# CFAA COURSE 4
LIFE SAFETY SYSTEMS ELECTRONICS

ERRATUM

CFAA, Course 4, Life Safety Systems Electronics
ISBN: 978-0-9734001-6-8

Date: June 28, 2017

Fig. 2 - Oscillator
Page 5-11 and Cover

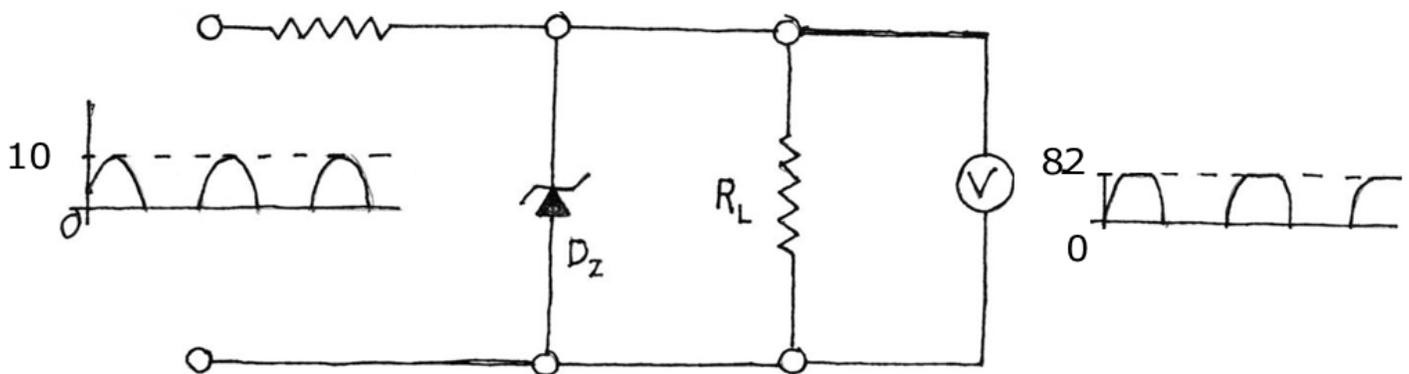
Cover
- See Figure 2 for corrections to the schematic shown on the cover.

Refer to Page 5-11, Section 5.4.8, <u>Oscillators</u>
Replace the diagram with the diagram shown in Fig. 2. Without the resistor added in Fig. 2, the oscillator will not oscillate.

Add Resistor

Fig. 1 — Application of Zener Diode

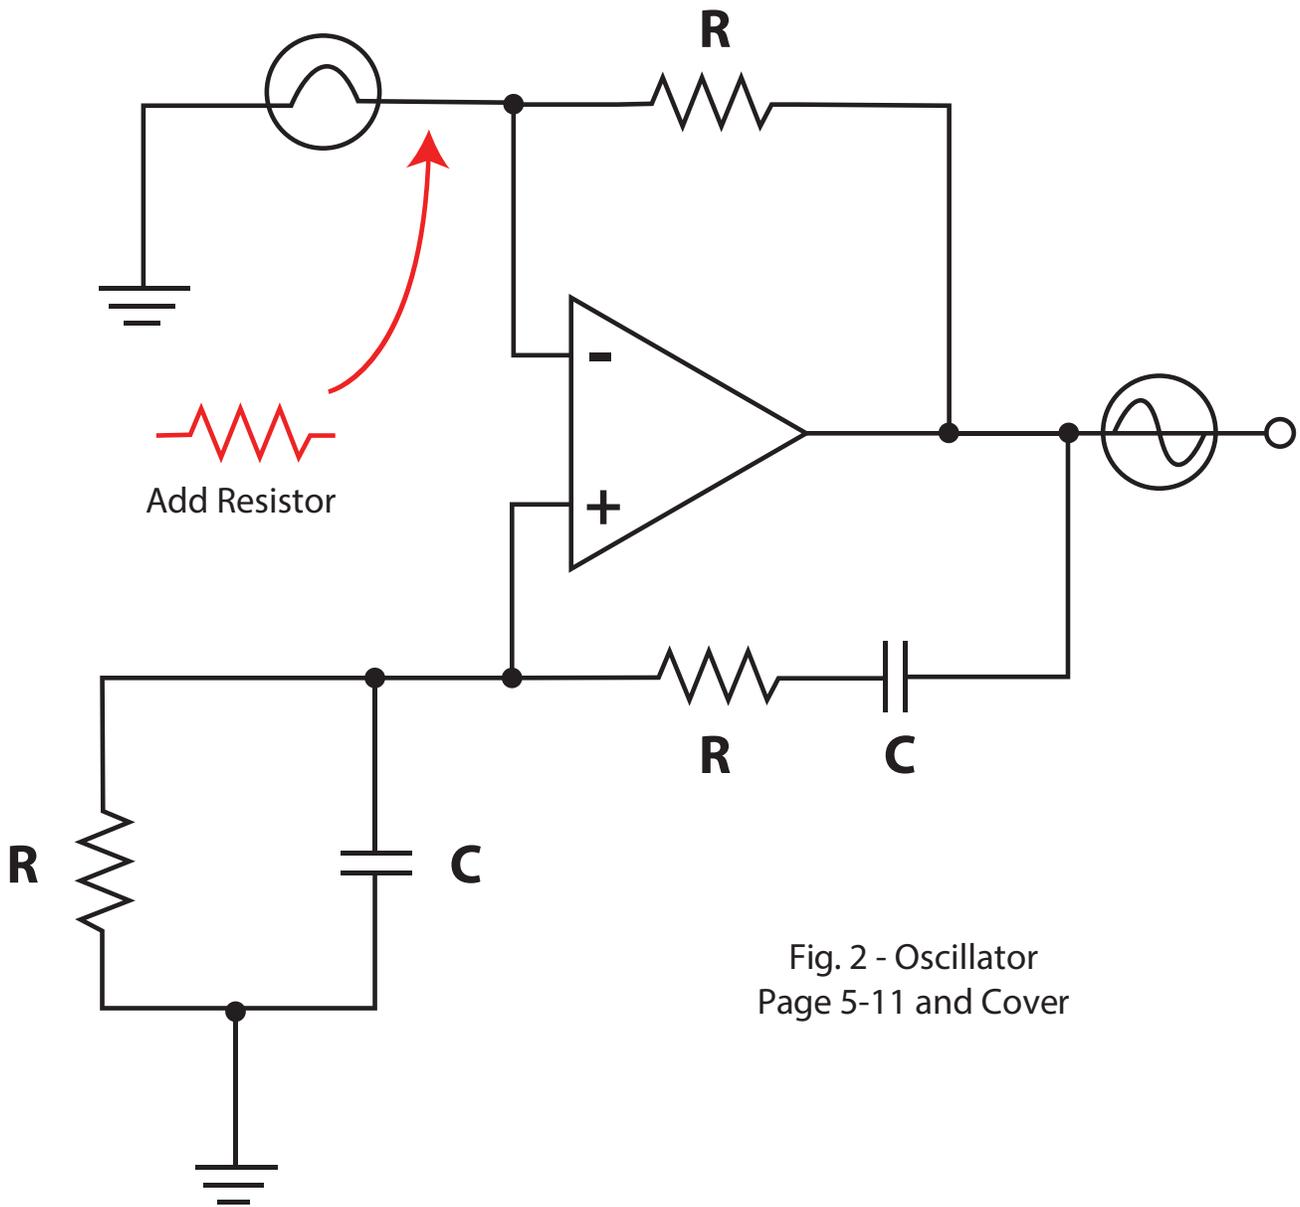
Module 1.3: <u>Voltage Regulators</u>
Refer to Page 1-17, Section 1.3.2, <u>Zener Diode</u>
Replace the schematic shown at the bottom of page 1-17 with the schematic shown in Figure 1.

Delete the following paragraph:
"A 20-volt peak-to-peak voltage applied to an 8.2 volt Zener diode will deliver an 8.2 volt positive reading with a negative 10 volt reading on an oscilloscope"

Add the following paragraph:
"A rectified half wave with a 10-volt peak applied to the circuit will deliver to the load, a rectified half wave with its peak shaved to 8.2 volts."
